New High School in Bungendore

State Significant
Development Application
(SSD-14394209)

Architectural + Landscape Design Report Addendum

Rev B
September 2022
Project No. 200096

12 Revised Covered Walkway Strategy

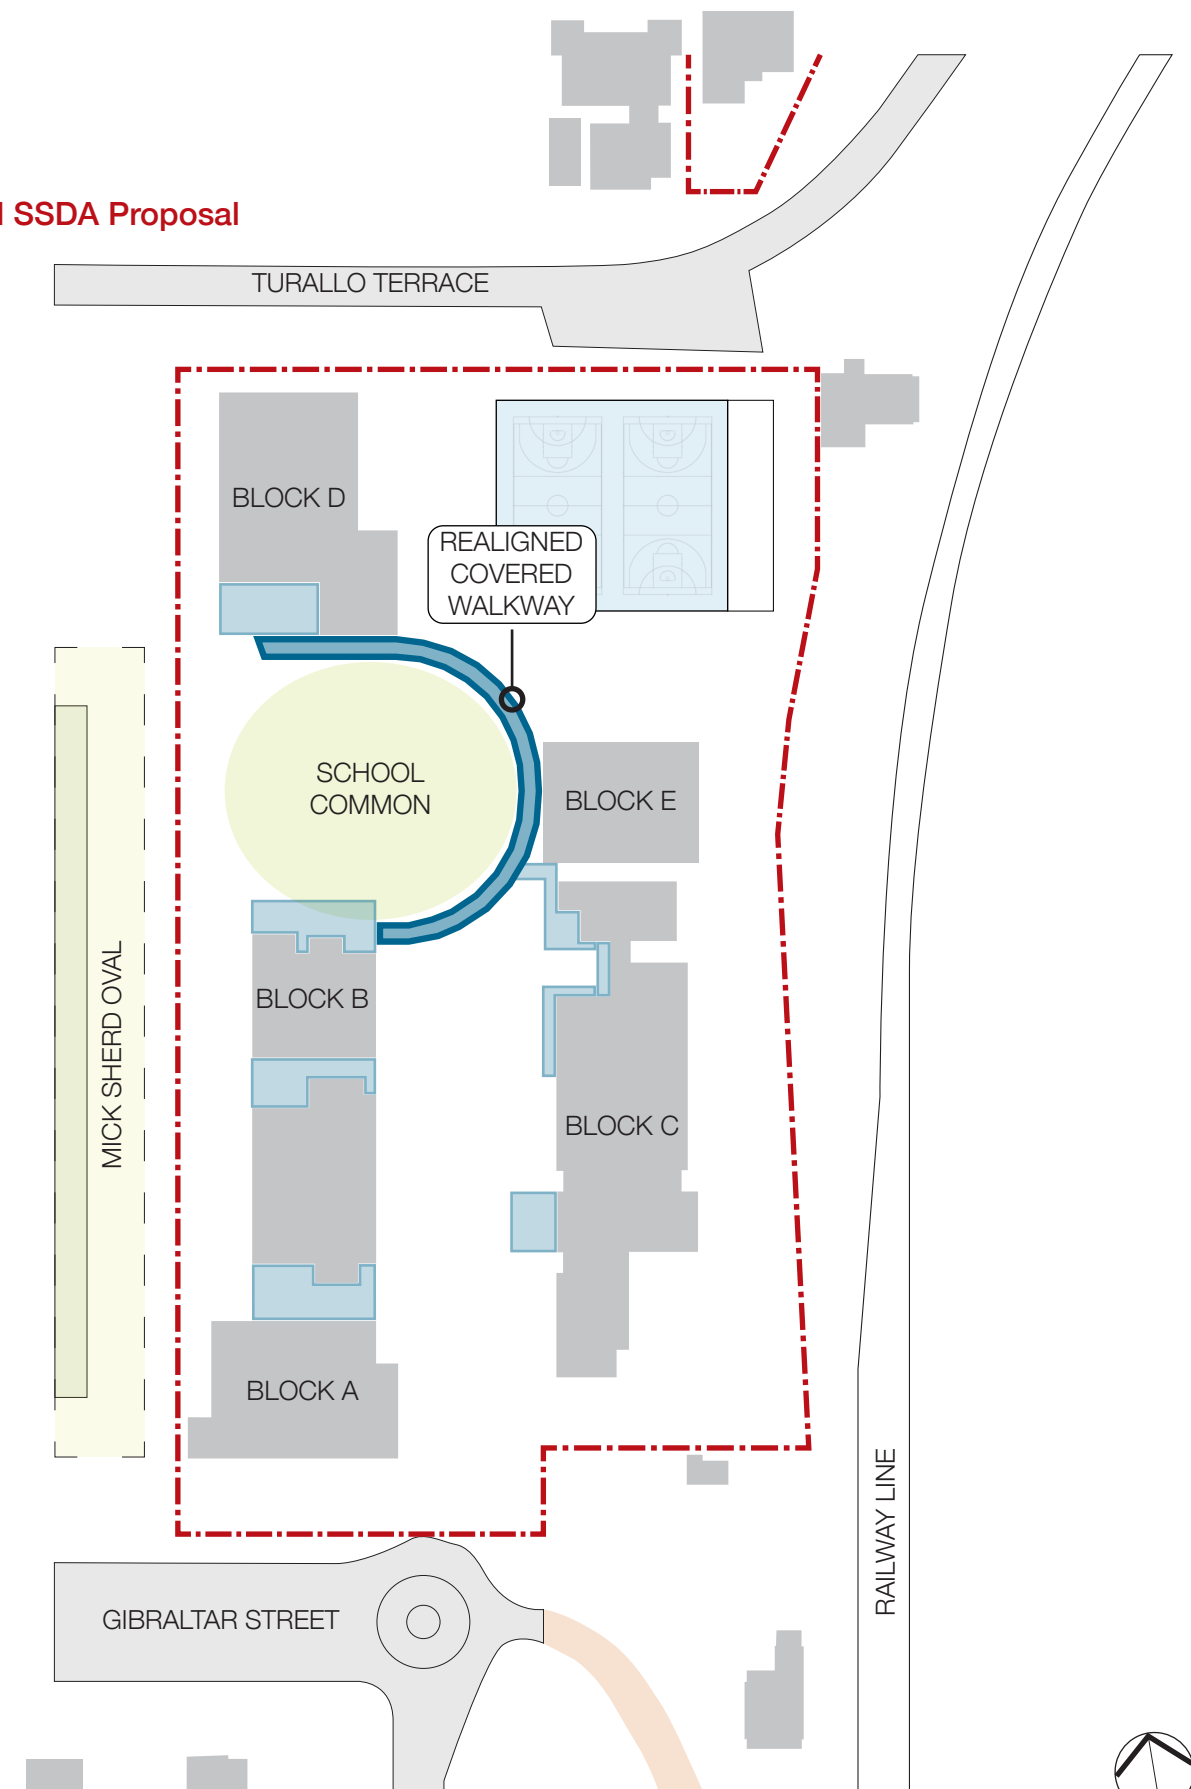
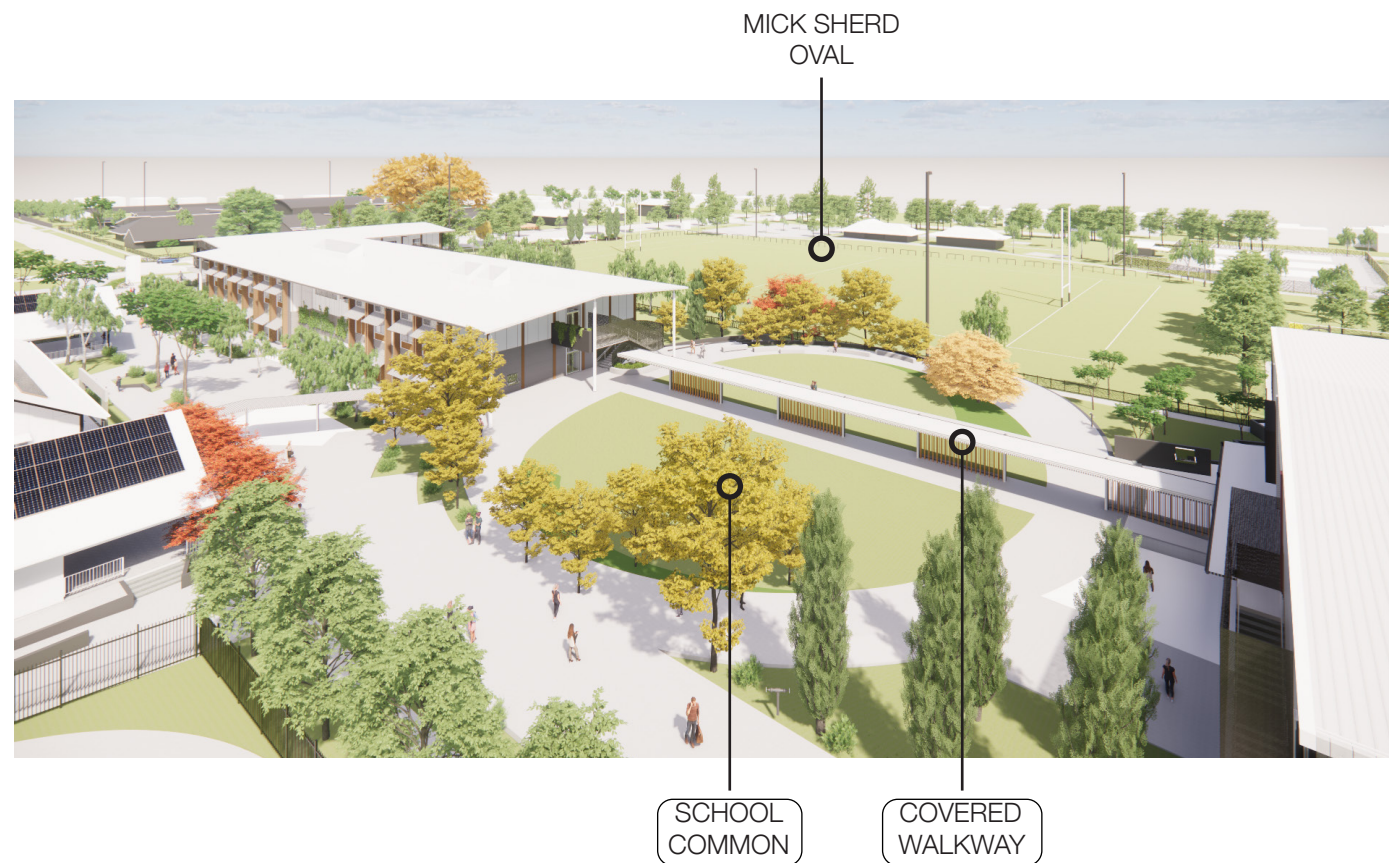
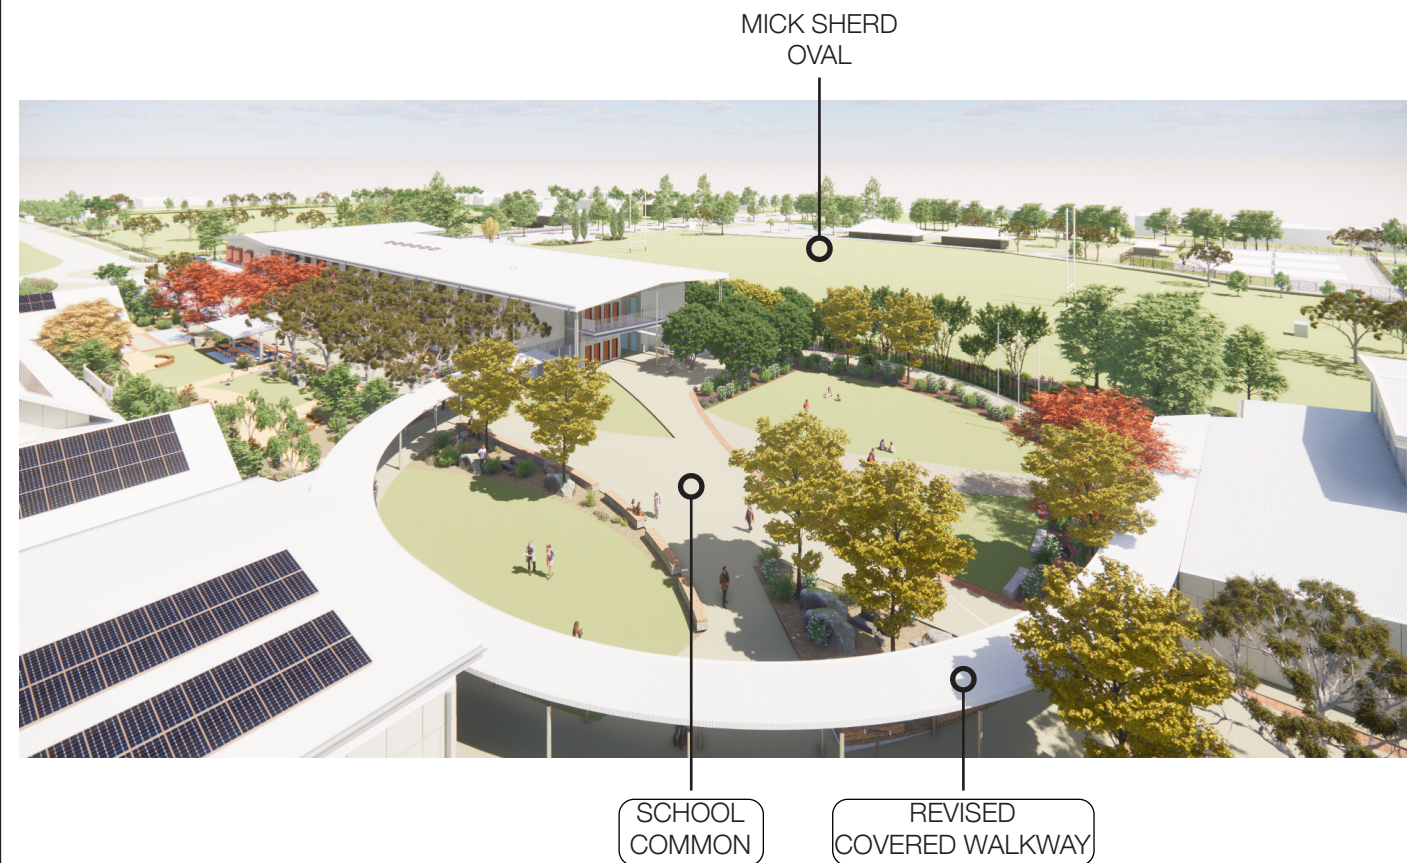
The covered walkway connection between Block B and Block D has been redesigned to define the oval shaped School Common as the 'heart' of the campus, and provide a new covered connection to the relocated School Library (Block E), enhancing the amenity to the school.

13 Fencing Strategy

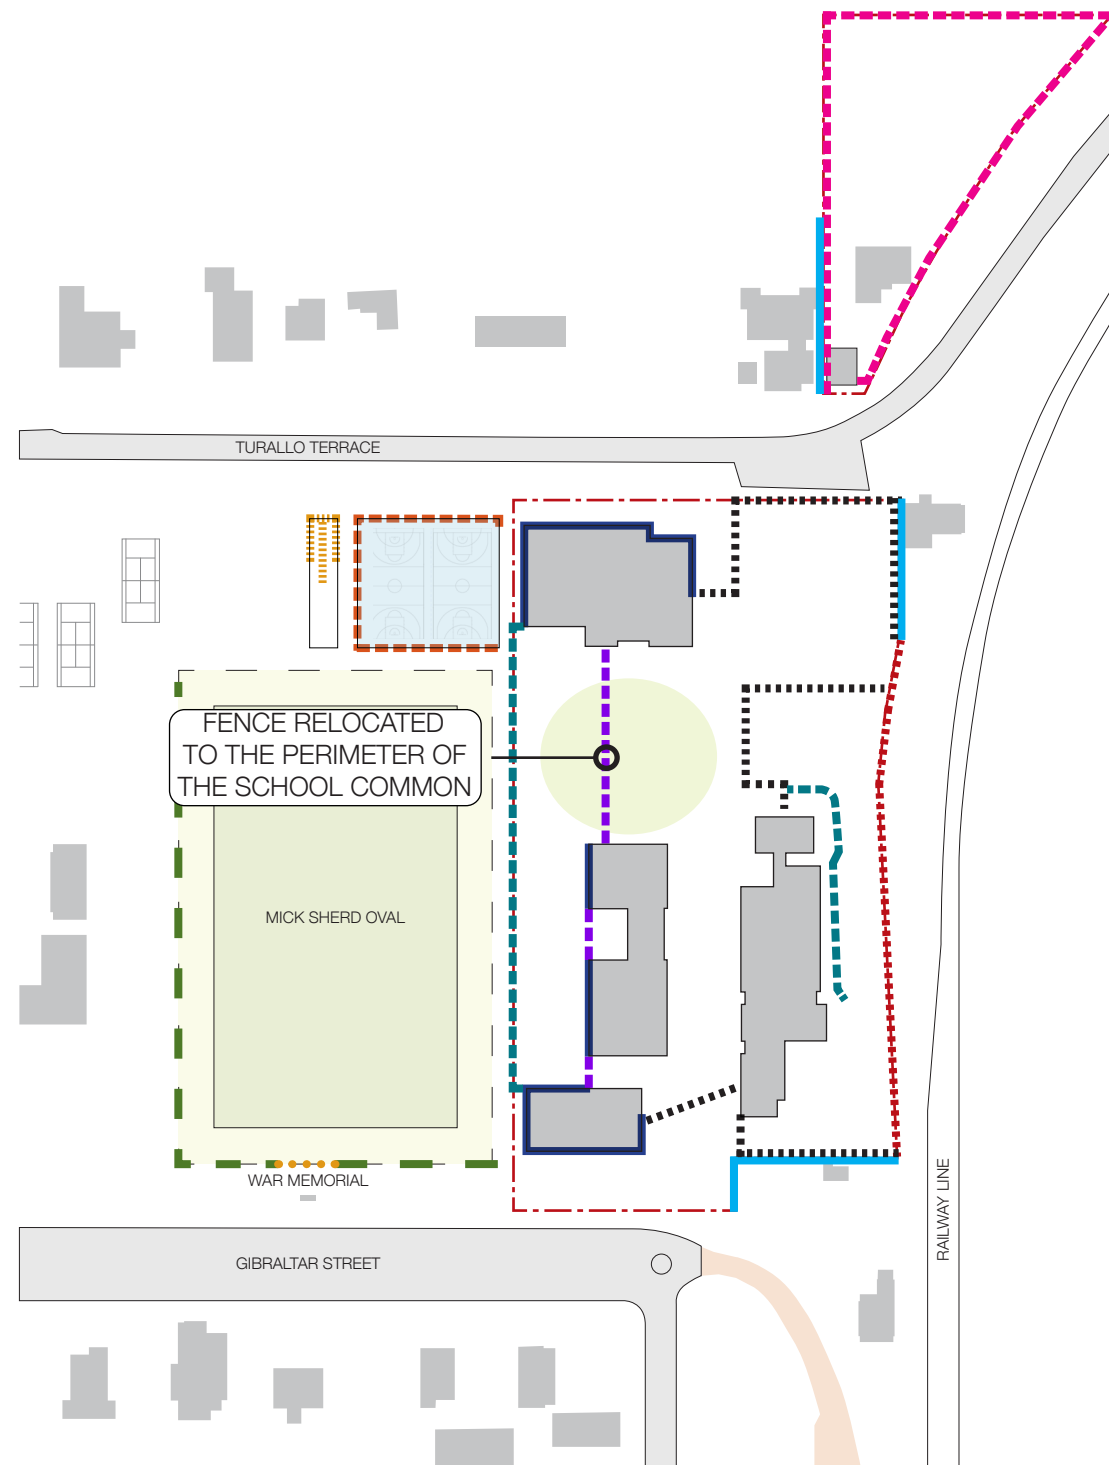
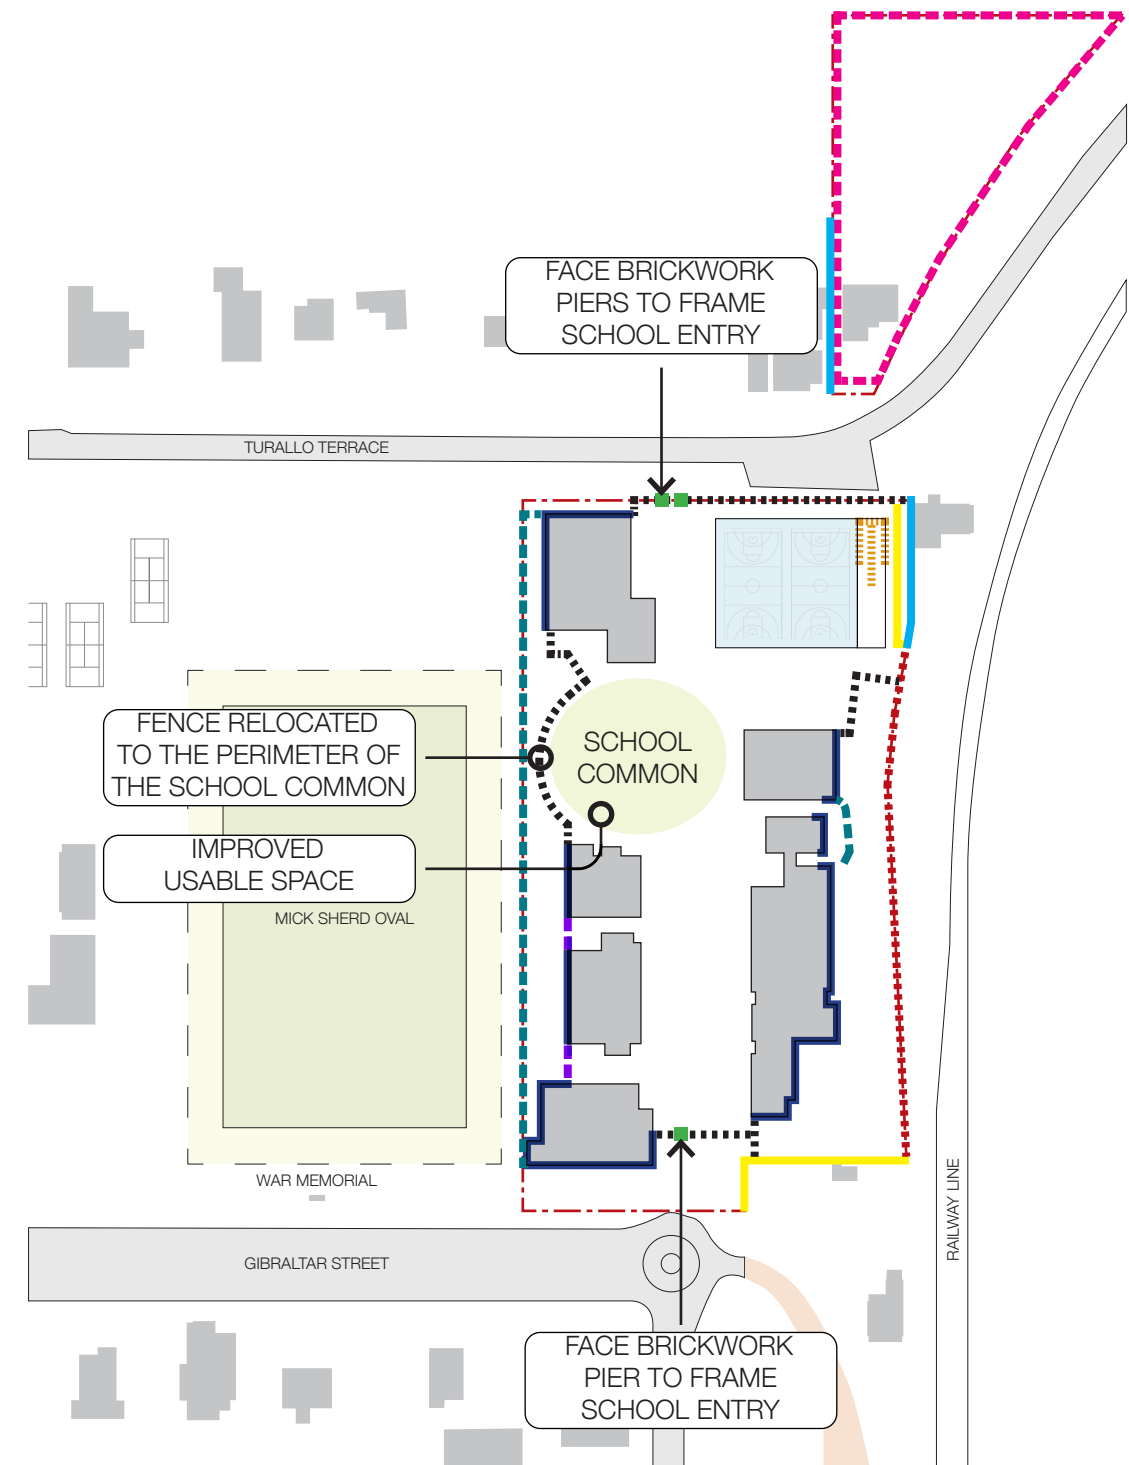
The school security fence between Blocks B and D has been redesigned to arc around the western perimeter of the School Common to provide a more versatile open space to the centre of the campus. The school security fence to the northern and southern boundaries has been rationalised and face brickwork piers have been introduced to define the school entries and complement the town's character. A new 2.1m high timber lap and cap fence is proposed to the adjacent Station Master's Cottage and Signmans Cottage. The fence type has been selected in response to heritage advice, to be sympathetic to the heritage character of the two properties.
